WARRANTY BULLETIN

Wb06-01

DATE : AUGUST 2006	SECTION : 06 - Electrical
EXPIRATION: AUGUST 2008	
SUBJECT : BAGGAGE COMPARTMENT DOOR SWITCH REPLACEMENT

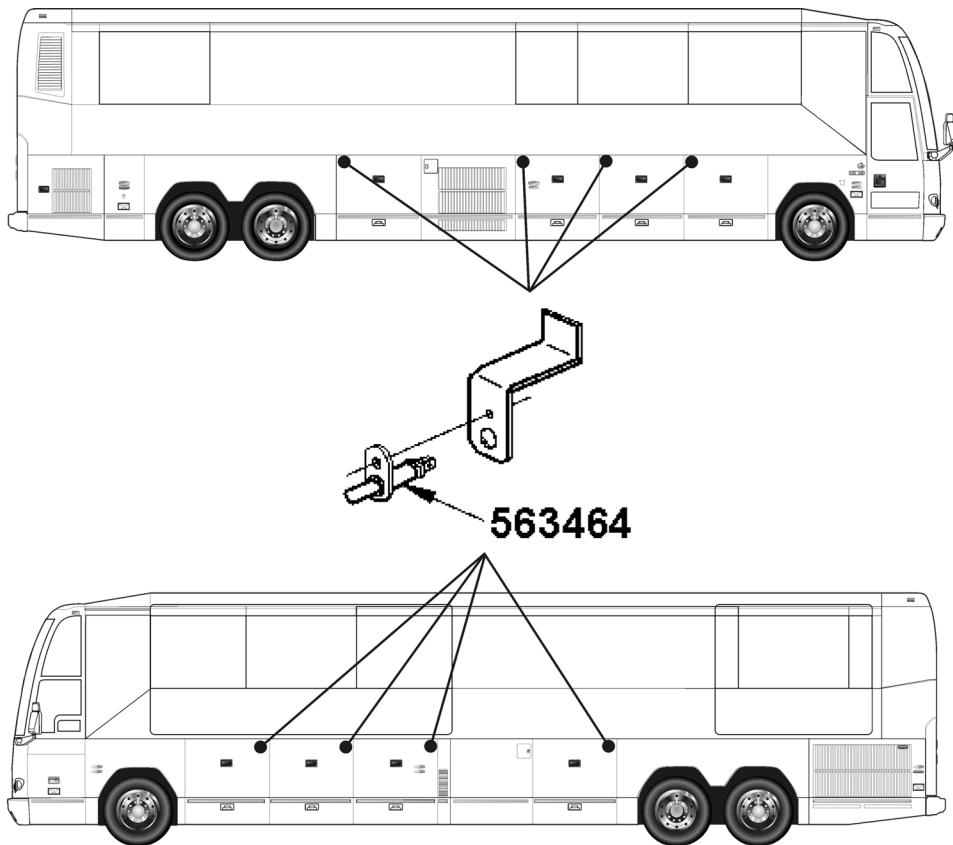
On the above-mentioned vehicles, problems with the switches of the baggage compartment doors can occur eventually. It is thus recommended to replace them in order to prevent these drawbacks.

1. Open baggage compartment door of the defective switch.
2. Disconnect red wire from the back of the switch.
3. Unfasten the screw fixing the switch onto its bracket.

4. Install and secure the new switch (563464) onto its bracket.
5. Reconnect red wire at the back of the switch then close and open baggage compartment door to check for proper operation.
